Model: Triton-C1 Duplex Unit (AD470)		Date: 28-Oct-04	No.: MB726001
Modified Article: Wall & Gear		Prepared by: M. Tsuyuki	
From: 1st Tech. Support Sec. Service Support Dept.			
Reason for Modification:	<input checked="" type="checkbox"/> Parts catalog correction <input type="checkbox"/> To facilitate assembly <input type="checkbox"/> Part standardization	<input type="checkbox"/> Vendor change <input type="checkbox"/> To improve reliability <input type="checkbox"/> Other	<input type="checkbox"/> To meet standards ()

Model: Triton-C1 Duplex Unit (AD470)		Date: 2-Aug-05	No.: MB726002
Modified Article: Plastic Brush		Prepared by: M. Tsuyuki	
From: 1st Tech. Support Sec. Service Support Dept.			
Reason for Modification:	<input checked="" type="checkbox"/> Parts catalog correction <input type="checkbox"/> To facilitate assembly <input type="checkbox"/> Part standardization	<input type="checkbox"/> Vendor change <input type="checkbox"/> To improve reliability <input type="checkbox"/> Other	<input type="checkbox"/> To meet standards ()

Model: Triton-C1 Duplex Unit (AD470)	Date: 2-Aug-05	No.: MB726002a
--------------------------------------	----------------	----------------

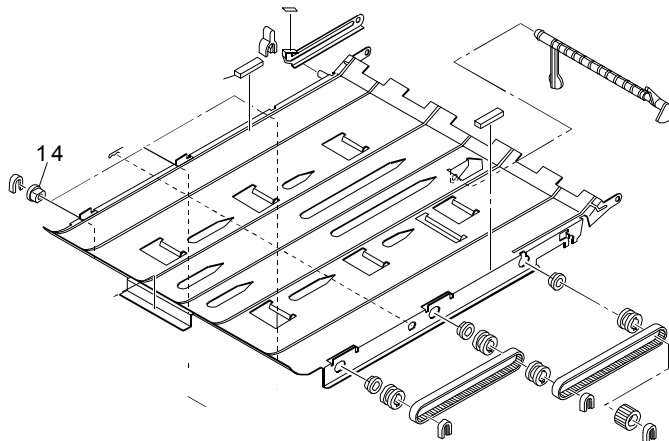
Please correct your parts catalog as follows:

Old part number	New part number	Description	Q'ty	Int	Page	Index
B7261010	B7267510	Wall(4402290800) Wall(4402908000)	1	X/O	3	9
B7262069	B7267669	GEAR(4402291060)	1	X/O	5	3

3.DRIVE SECTION 2

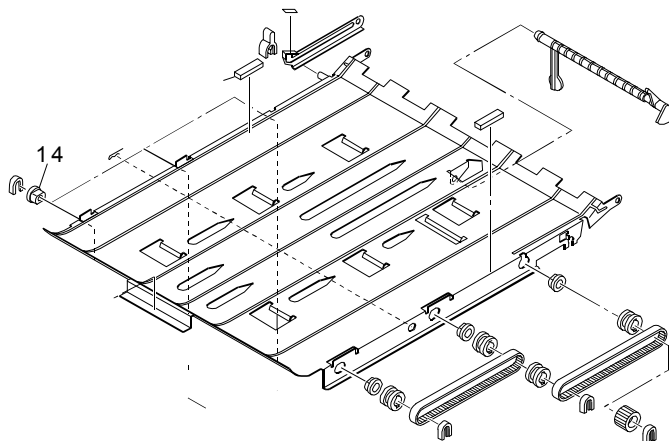
The items in bold italics have been corrected or added.

Change/Reason: The Parts Catalog was corrected as follows.

Old part number	New part number	Description	Q'ty	Int	Page	Index
B7262114	B7262214	<i>Plastic Bush</i> (4402294980) <i>Plastic Bush</i> (4407734980)	<i>1→3</i>		7	14
